Anthropomorphic Test Devices; Hybrid III Test Dummy, ES-2re Side Impact Crash Test Dummy

ACTION: Notice of proposed rulemaking (NPRM).

SUMMARY: This document proposes corrections or minor changes to some of the drawings incorporated by reference

Figure 1: Corrections to pendulum dimensions in Figure 22 of Section 572.33(c)(3)

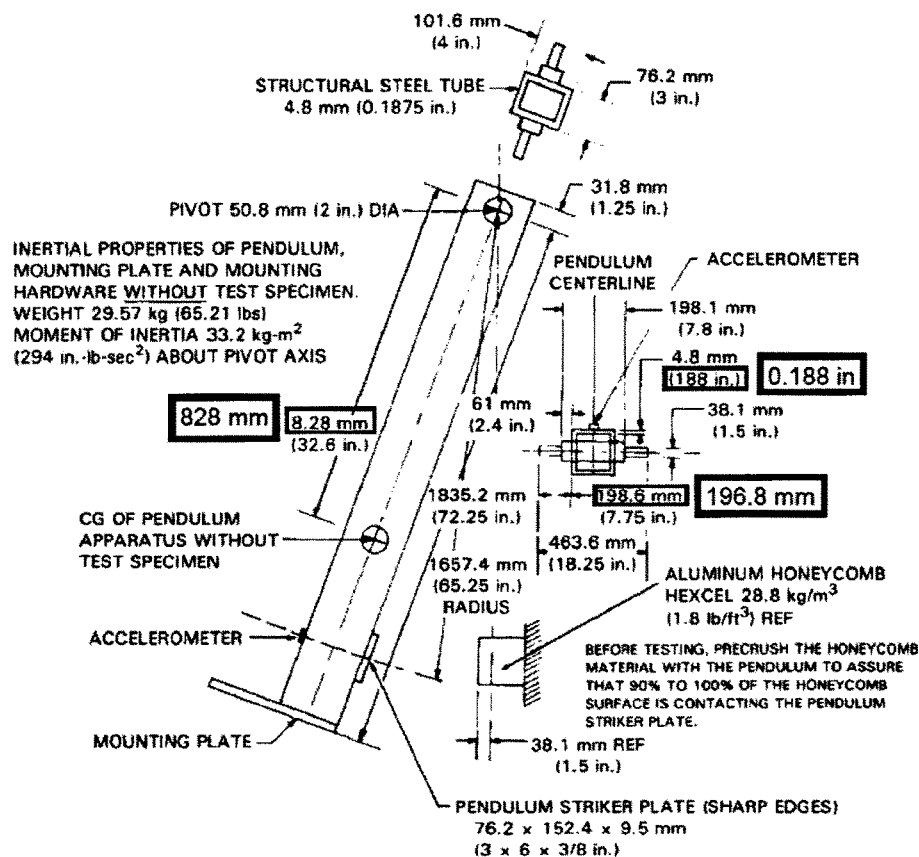
NHTSA observed that Figure 22, “Pendulum Specifications,” of 49 CFR part 572 has several dimensional errors that need correction. This pendulum is used in neck qualification tests for the ES–2re as well as other adult crash test dummies, including the Hybrid III 50th percentile male and 5th percentile female frontal crash test dummies, the SID–IIIs 5th percentile female side impact dummy, and the SID and SID/HIII side impact crash test dummies. The dimensional corrections that should be made to this figure are listed below and shown in Figure 1 of this preamble, below:

- The 8.28 millimeter (mm) (32.6 inch (in)) dimension should be 828 mm (32.6 in);
- The 4.8 mm (188 in) dimension should be 4.8 mm (0.188 in);
- The 198.6 mm (7.75 in) dimension should be 196.8 mm (7.75 in).

FIGURE 22
PENDULUM SPECIFICATIONS

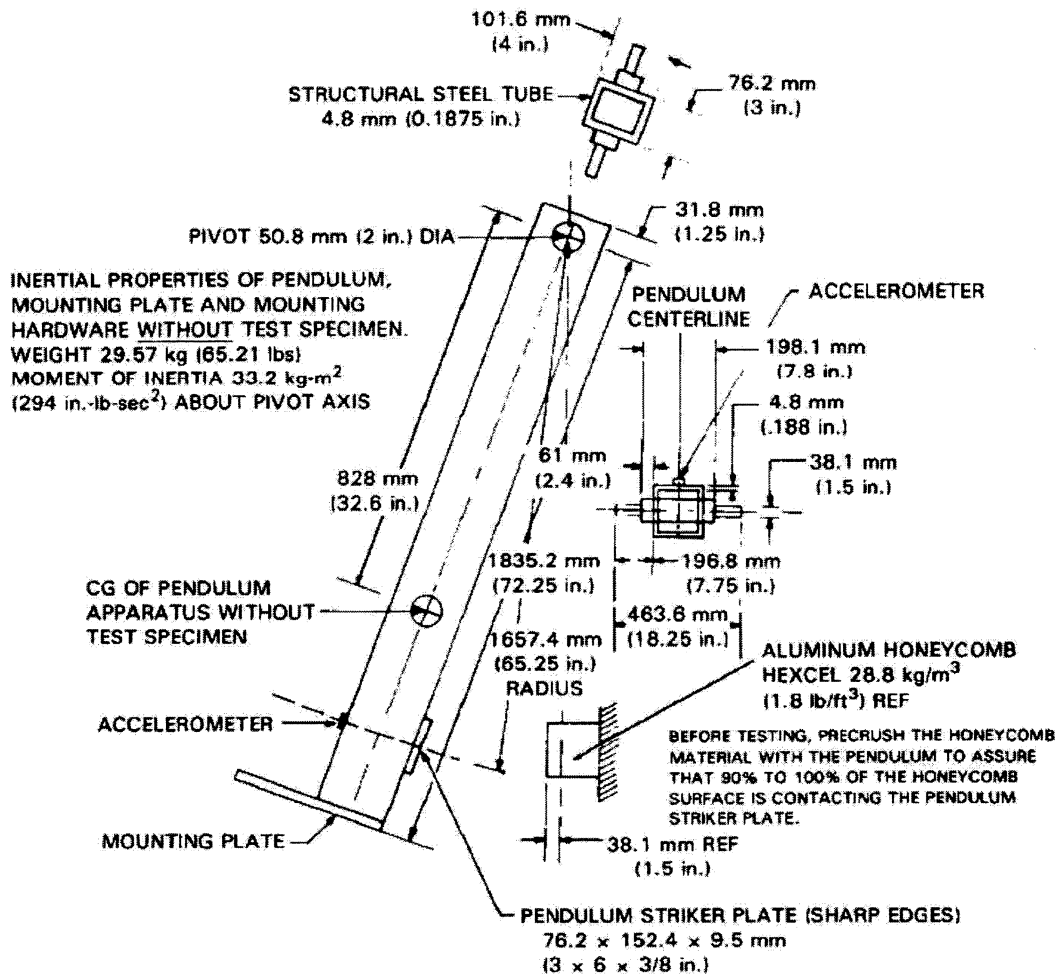
2. In § 572.33, revise Figure 22 following paragraph (c)(3) to read as follows:
